Southern Nuclear Operating Company
Vogtle Early Site Permit Application
Supplement To Provide Additional Seismic Analysis

Vogtle Early Site Permit Application

Supplement 4-S1*

NOTE: This enclosure contains Supplement 4-S1 pages for the following ESPA SSAR sections:

Figure 2.5.2-65a Vogtle Strain Compatible Profiles (S-Wave Velocity)

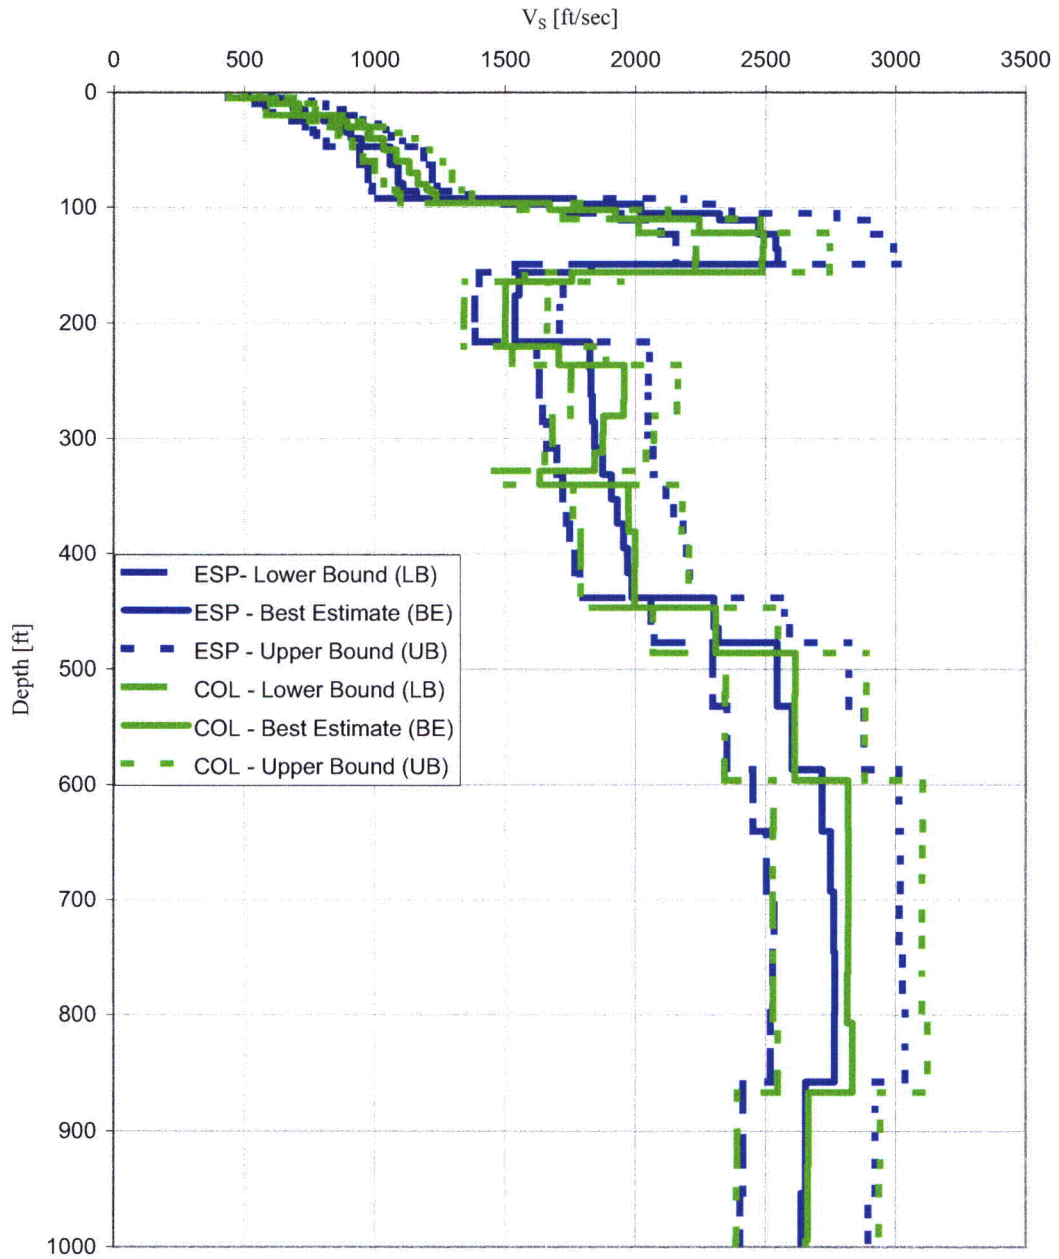
To provide a consistent soil amplification for comparison with the results using COL data, from the ESP set of runs described in Section 2.5.2.5.1, the strain-compatible velocity and damping profiles were used to obtain the median and upper and lower bound profiles (using one standard deviation as the variation). The velocity and damping profiles are compared with the corresponding profiles from the analysis of the COL data in Figures 2.5.2-65a and 2.5.2-65b,

Figure 2.5.2-65b Vogtle Strain Compatible Profiles (S-Wave Damping)

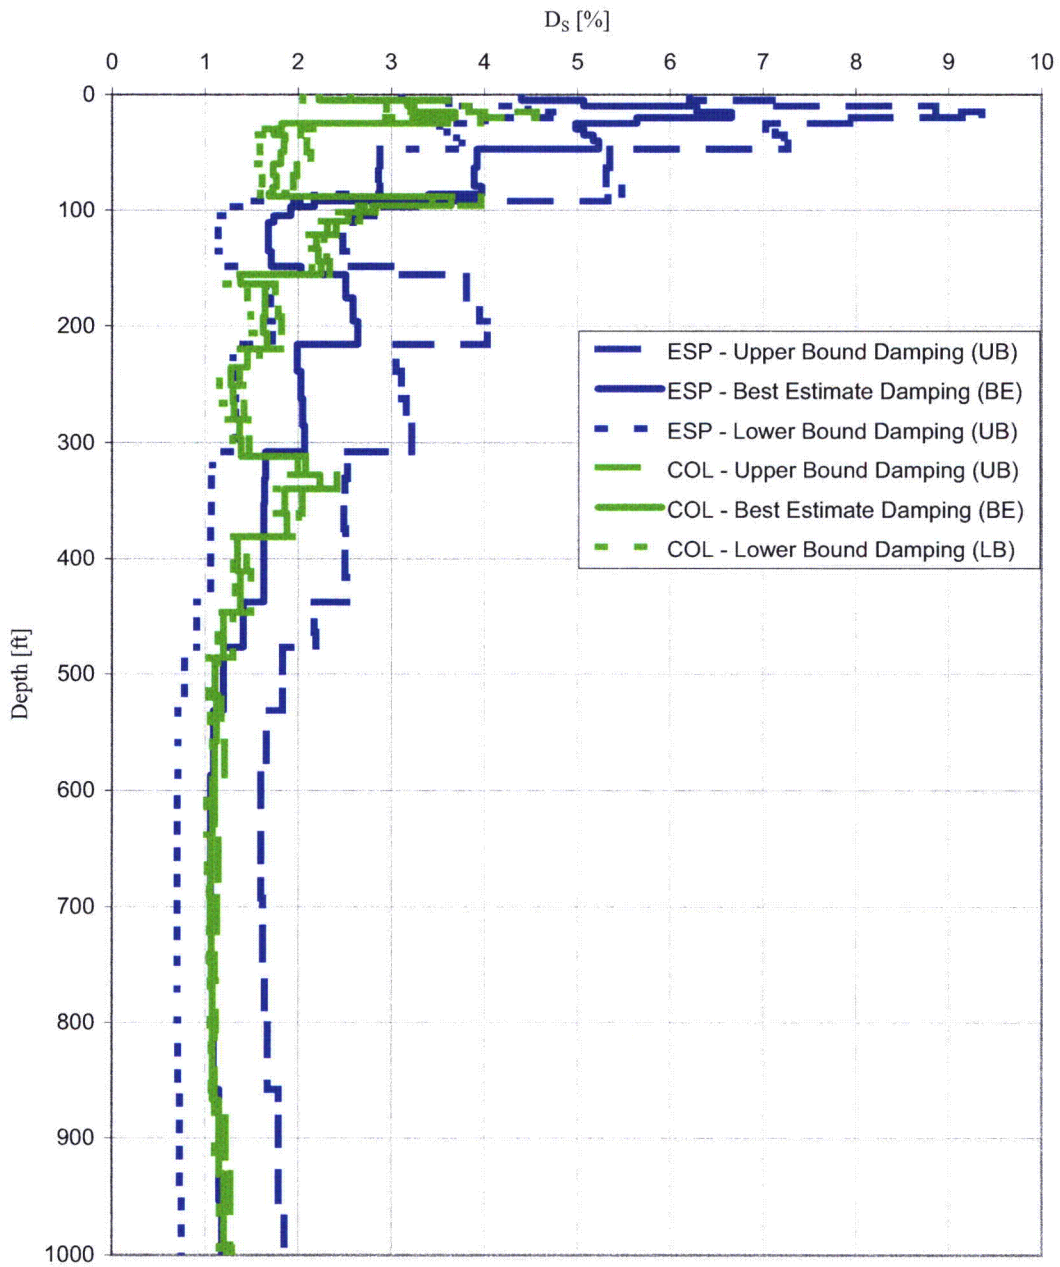
respectively. Except for the damping profile at shallow depths, the two sets of data are consistent. The three profiles selected from the analysis of the ESP data were subsequently analyzed using the same three HF and LF time histories used in the analysis of the COL data. Since the soil properties are already compatible with shear strains, no further iteration on soil properties was performed. The results in terms of acceleration response spectrum at 5% damping at 40 ft depth as outcrop motion were obtained. The spectra for each HF and LF motions were averaged over the three time histories and over the three profiles. The averaged responses were divided by the respective HF and LF response spectra at MAFE of 10^{-4} and the resultant amplifications were enveloped. Figure 2.5.2-65c shows the amplification labeled as ESP.

Figure 2.5.2-65c Envelope at 40 ft depth (FIRS horizon)

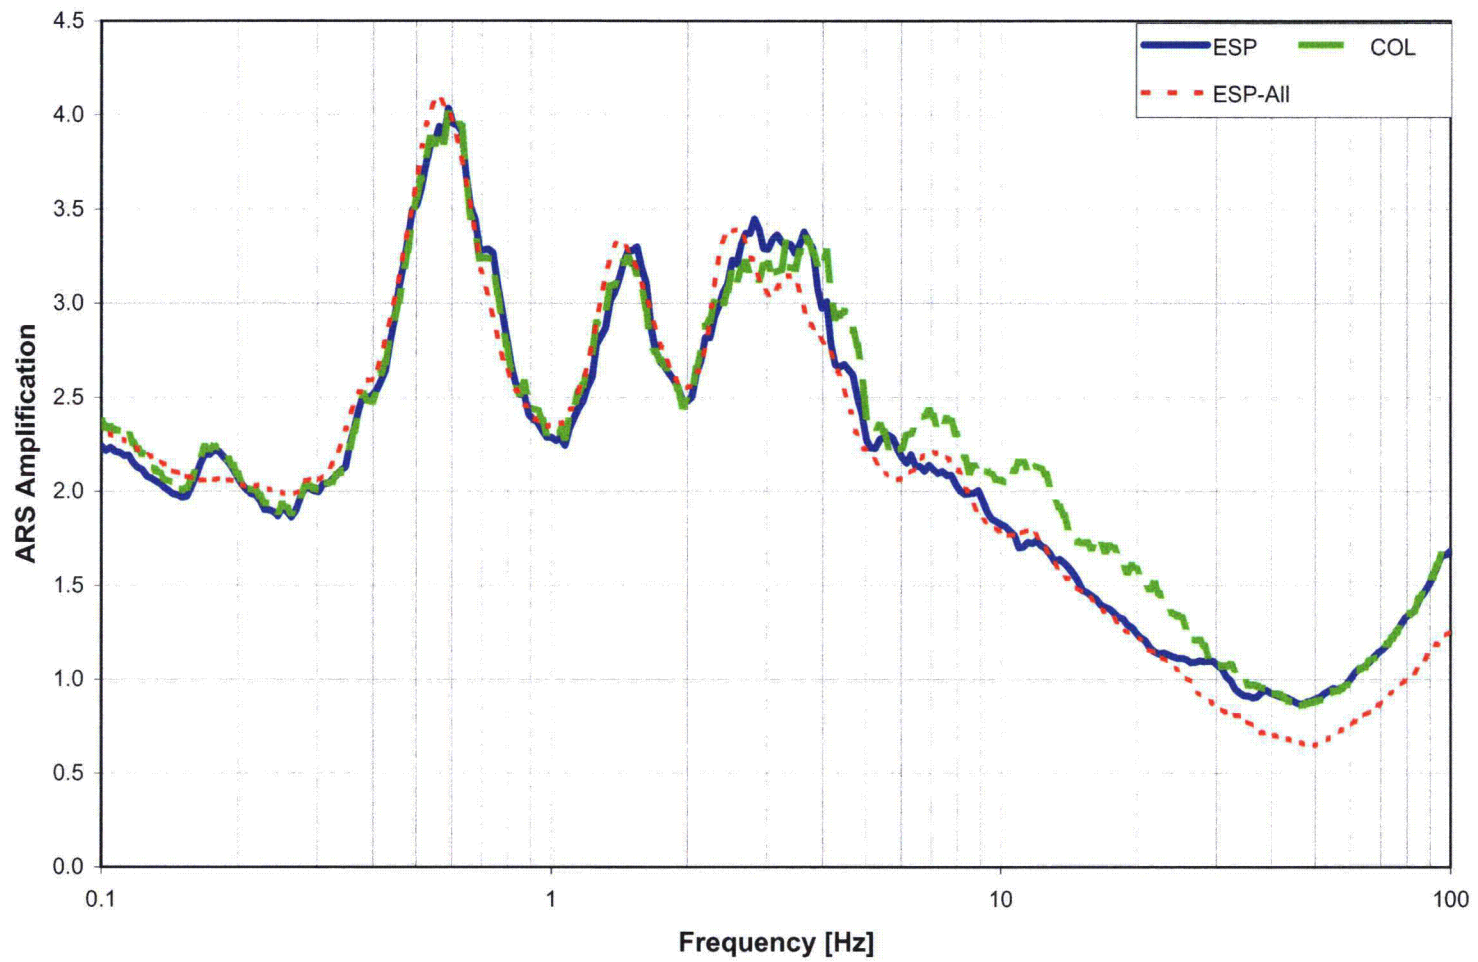
Using the best estimate COL velocity profile (Figure 2.5.4-7a), the upper bound and lower bound profiles were developed using a variation of the data set. The three COL velocity profiles and the associated COL strain-dependent soil properties were analyzed using three HF and three LF time histories corresponding to MAFE of 10^{-4} . All analyses were performed twice to consider the low and high PI strain-dependent soil properties for BBM (Figures 2.5.4-19b and 2.5.4-20b). Several iterations were performed in each run to converge on the soil properties. The strain-compatible velocity profiles and damping profiles obtained from the analysis are shown in Figure 2.5.2-65a and 2.5.2-65b labeled as COL. From each run, the response motion in terms of 5% acceleration response spectrum at the depth of 40 ft as SHAKE "outcrop" motion was computed. The results of HF input motion were averaged over the three time histories and over the three soil profiles as well as the low and high PI cases of the BBM. The same averaging method was used for the LF input motions. The averaged results were divided by the corresponding HF and LF input response spectrum at MAFE of 10^{-4} to compute the spectral amplification at the 40 ft horizon. The resultant two amplifications curves were enveloped. The enveloped amplification values are shown in Figure 2.5.2-65c labeled as COL.

To confirm the adequacy of the limited number of profiles and time histories for the purpose of this evaluation, the amplification corresponding to the analyses of the fully randomized ESP soil profiles (Section 2.5.2.) is also shown in Figure 2.5.2.65c labeled as "ESP-all". The comparison of the two sets of results based on ESP data shows the selection of limited number of profiles and time histories are adequate for the purpose of the evaluation of the impact of the COL data. Furthermore, the comparison of the amplification between ESP and COL data is considered small and is expected to be reduced to be negligible if the fully randomized soil profiles were used in the COL set of analyses.

Figure 2.5.4-7a Shear Wave Velocity Profile – ESP and COL Soil Columns

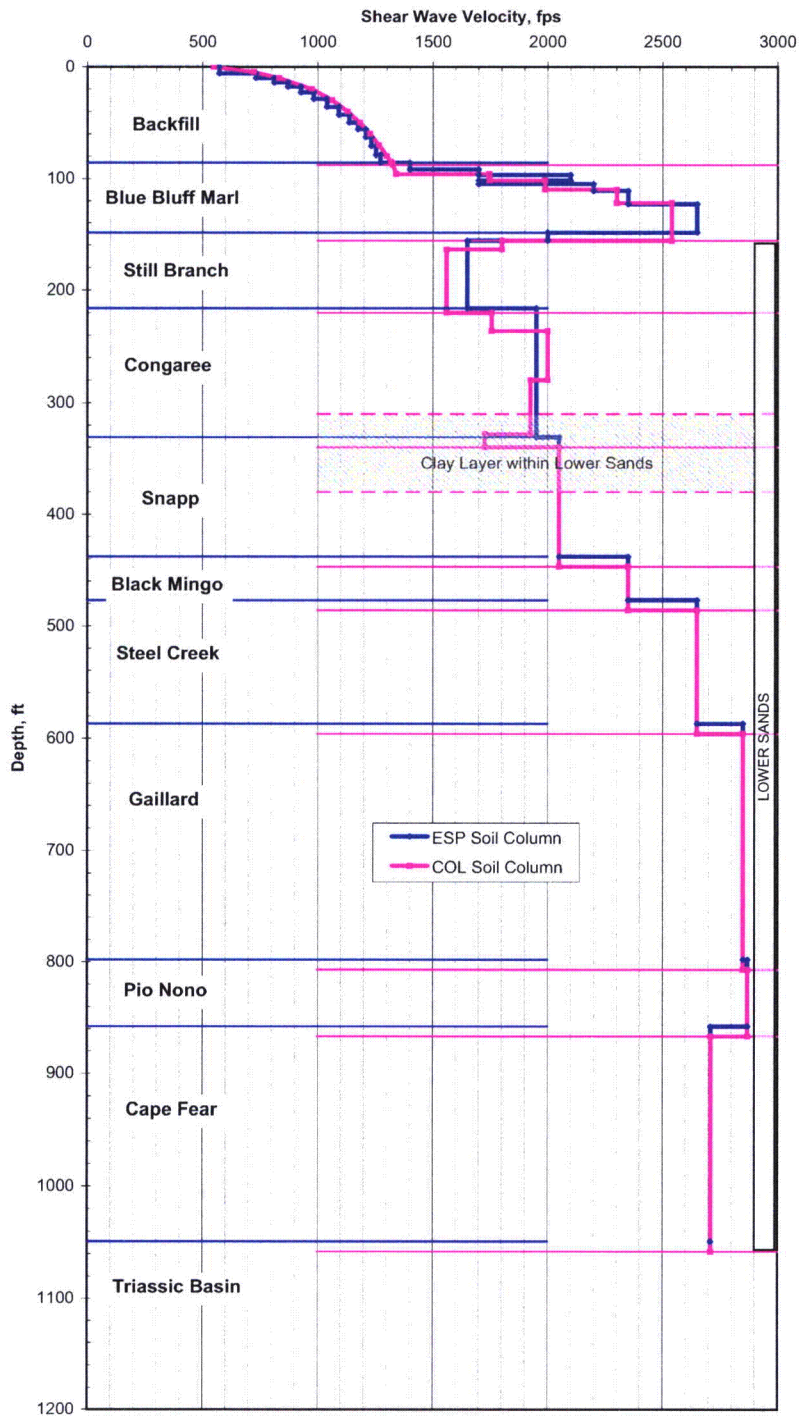
The stratification and shear wave velocity profiles for the ESP and COL soil columns are presented in Figure 2.5.4-7a. The offset in soil stratification between the soil columns reflects refinements due to the additional data collected during the COL investigation. The stratification of the ESP soil column is based on the deep boring, B-1003. The stratification of the COL soil column is based on numerous additional borings in the power block areas. The data disclosed thicker near surface strata as compared boring B-1003. No additional stratification or shear wave velocity data below the top of the Snapp Formation in the Lower Sands were collected during COL investigation; therefore, the COL soil column stratification and shear wave velocity profiles between the Snapp Formation and the top of the Triassic Basin bedrock were carried over from the ESP soil column with the same strata thicknesses but slightly shifted in depth to

match the thicker near surface strata. Comparison of the two shear wave velocity profiles indicates good agreement between the data sets. Trends within the strata are consistent.

Figure 2.5.4-19a Comparison of Shear Modulus Reduction Curves - Backfill Soils

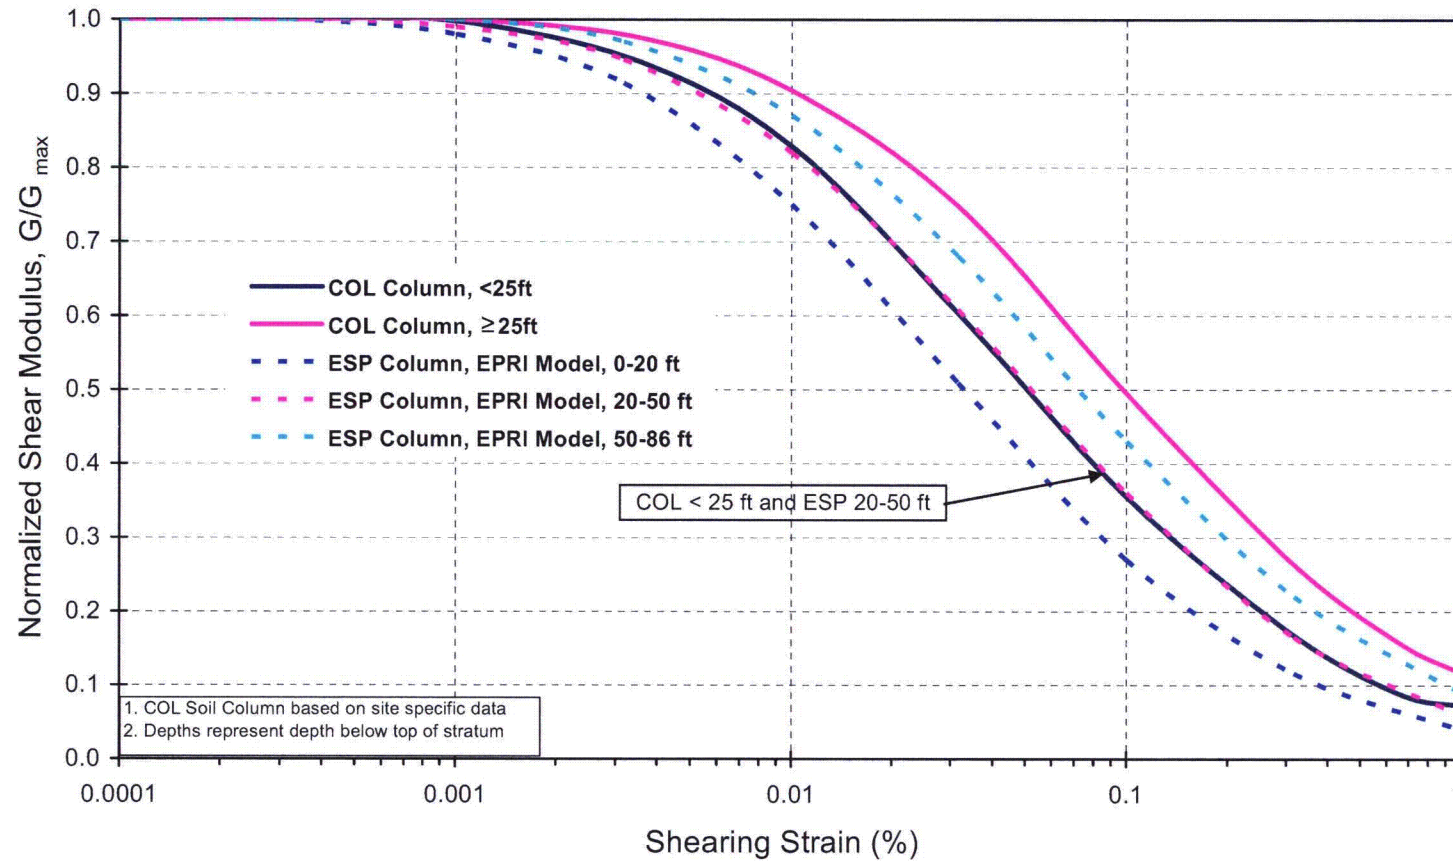
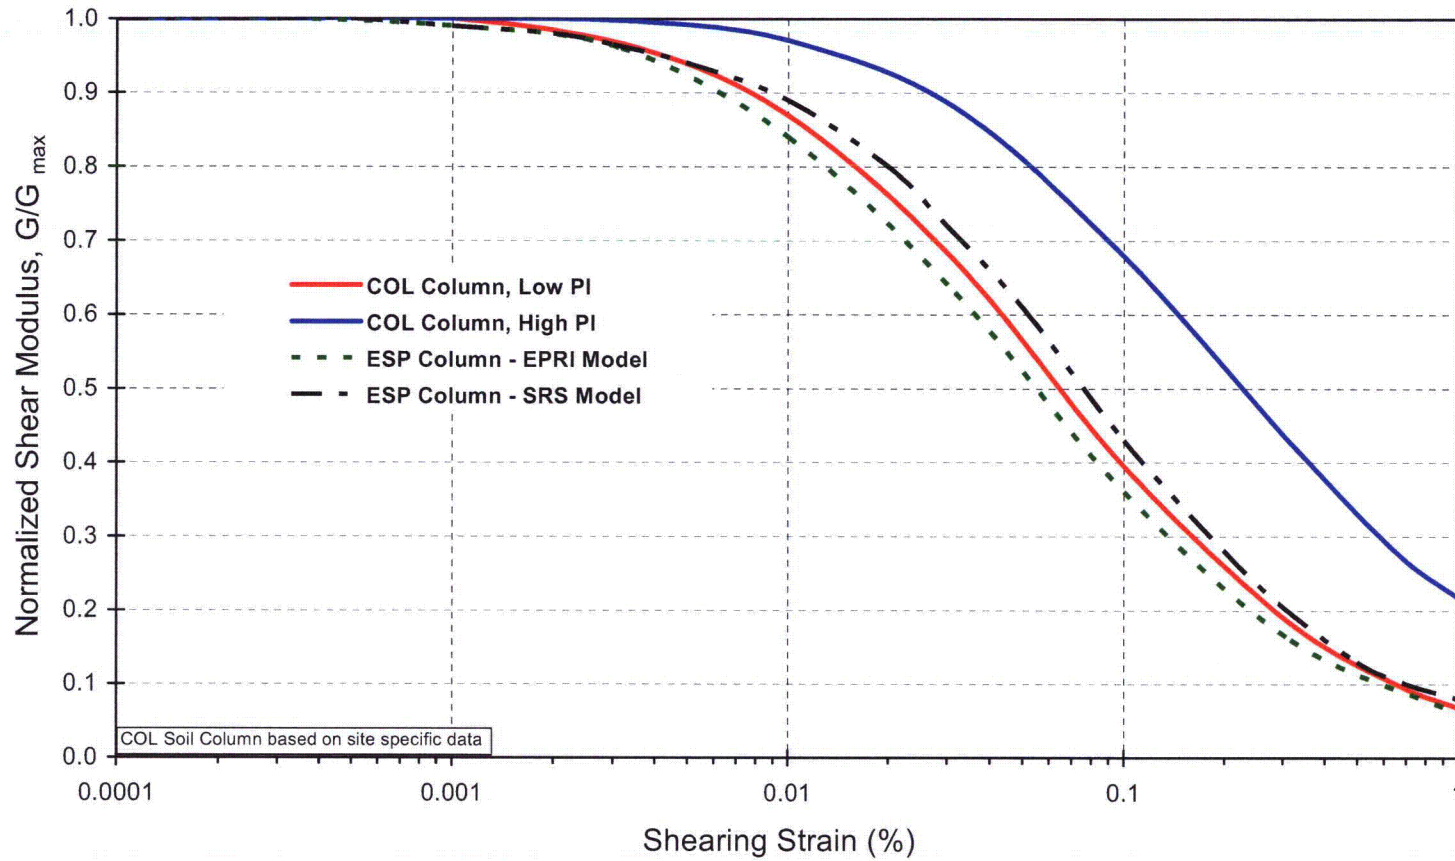
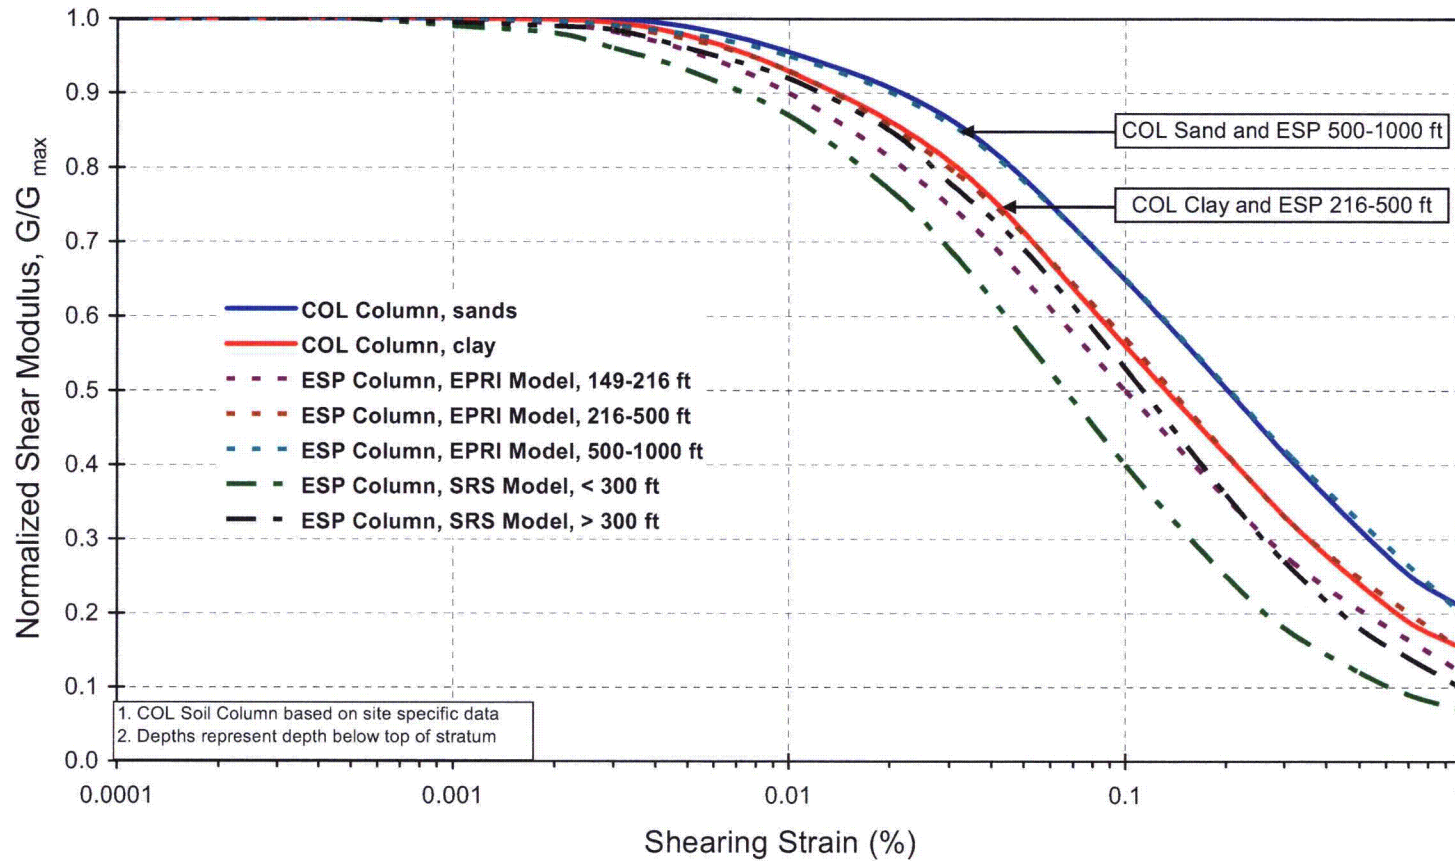
Comparisons of the soil non-linearity curves used for ESP and COL are presented in the attached Figures 2.5.4-19a through 2.5.4-20c. Figures 2.5.4-19a, 19b, and 19c illustrate the normalized shear modulus vs. shear strain curves for compacted backfill, Blue Bluff Marl, and Lower Sands, respectively. Figures 2.5.4-20a, 20b, and 20c illustrate the soil damping vs. shear strain curves for the same strata. The figures include both the site specific curves developed during the COL investigation and the EPRI and SRS model curves assigned during the ESP investigation. The COL site specific data for the Lower Sands includes non-linearity curves for both sand and clay materials in this stratum. Generally the figures suggest that the subsurface soils behave more linearly (provides a smaller reduction in shear modulus and less damping) than the models used for the ESP investigation.
